# RESOLUTION HOLDING HEARING ON REQUEST FROM RIVERPOINT WEST, LLC FOR A 2ND AMENDMENT TO THE RIVERPOINT FLEX OFFICE PARK WEST PUD CONCEPTUAL PLAN ON PROPERTY LOCATED AT 209 SOUTHWEST 9TH STREET

Communication from the City Plan and Zoning Commission advising that at their meeting held May 21, 2015, the following action was taken regarding a request from Riverpoint West, LLC (owner) represented by Anthony Kuechle (officer) for a 2<sup>nd</sup> Amendment to the Riverpoint Flex Office Park West PUD Conceptual Plan on property located at 209 Southwest 9<sup>th</sup> Street.

**APPROVAL** of staff recommendation of the proposed amendment to the PUD Conceptual Plan, subject to the following conditions: (ZON2015-00073)

#### ZON2015-00073

AMENDED PUD

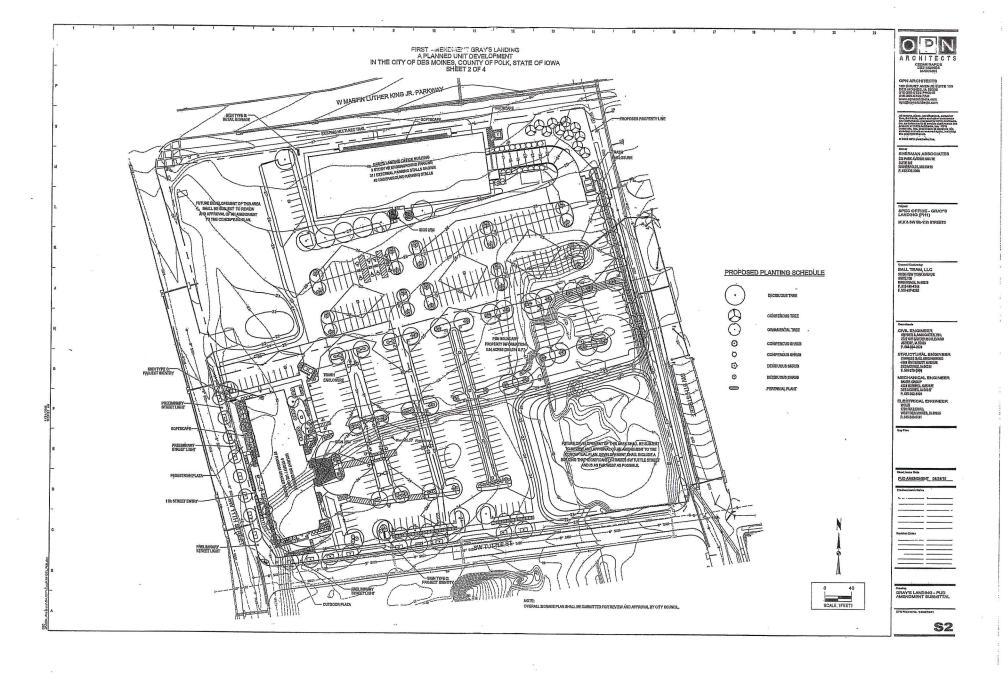
The proposed office building would have a 20-foot setback from the front property line along West Martin Luther King Jr. Parkway and would have two entrances oriented toward this parkway. The submitted drawings show a transformer at the east edge of the proposed building along MLK Jr. Parkway. Given its visibility, staff recommends that the transformer be moved interior to the site and be screened using landscape planting material so that it is not visible from the public right-of-way.

- The submitted PUD Conceptual Plan indicates that storm water will be managed through the combined use of a traditional sewer/intake system and an underground storm water quality detention system. On-site storm sewer facilities will connect to a proposed public storm sewer being constructed as part of the Tuttle Street improvements. This storm sewer will connect to the existing public storm sewer located along Southwest 11<sup>th</sup> Street. Staff recommends that a note be added to state that the areas dedicated for future development shall not be used for stormwater detention.

- 4. Landscaping: The PUD Conceptual Plan states that the site will be landscaped in accordance to the Landscape Standards as applicable to the "C-3" District. It demonstrates a mix of overstory trees, ornamental trees, shrubs, and landscaping beds. Staff recommends additional landscaping and an ornamental fence be provided along the northern perimeter of the parking lot to provide an urban edge along West Martin Luther King, Jr. Parkway.

Also, the submitted PUD Conceptual Plan demonstrates a sign to the south of the building that would only be visible internal to the site. The PUD Conceptual Plan should provide further clarification on which sign type this would be.

- 4. The transformer shall be shifted south within the site and shall be screened by plant materials in order to minimize its view from West Martin Luther, King, Jr. Parkway.

- 5. Provision of a note stating that the portions of the PUD Conceptual Plan dedicated for future development shall not be used for stormwater detention until future development of these areas occurs in accordance with a future PUD Conceptual Plan amendment

- 8. All freestanding signage shall be in accordance with the overall signage plan for the Gray's Landing Office Park.
- Provision of additional information on the sign internal to the site that would be located to the south of the proposed office building.

BUILDING ELEVATION
PUD AMENDMENT
SUBMITTAL

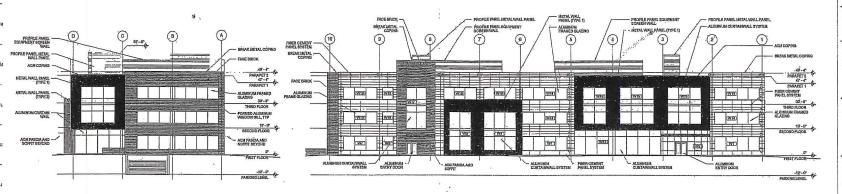
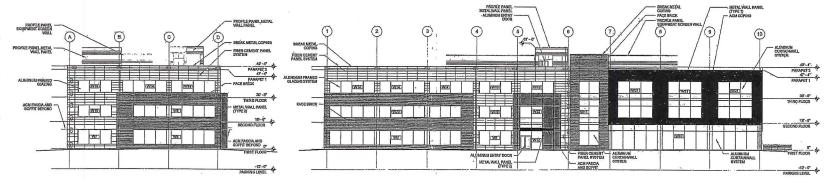
- 2. Urban Design: The proposed elevations indicate that the office building would be 3 stories with a maximum height of 49.5 feet. It would have a flat roof with a rooftop patio. The submitted elevations demonstrate the building would be sided with a contemporary composition of glass, brick, metal, and fiber cement panels. It would contain two entrances oriented toward West Martin Luther King, Jr. Parkway. The City's Urban Design Review Board reviewed the architectural design of the proposed building at their meeting on October 21, 2014

Will Page asked if the first sign shown on the far left is taller than the building.
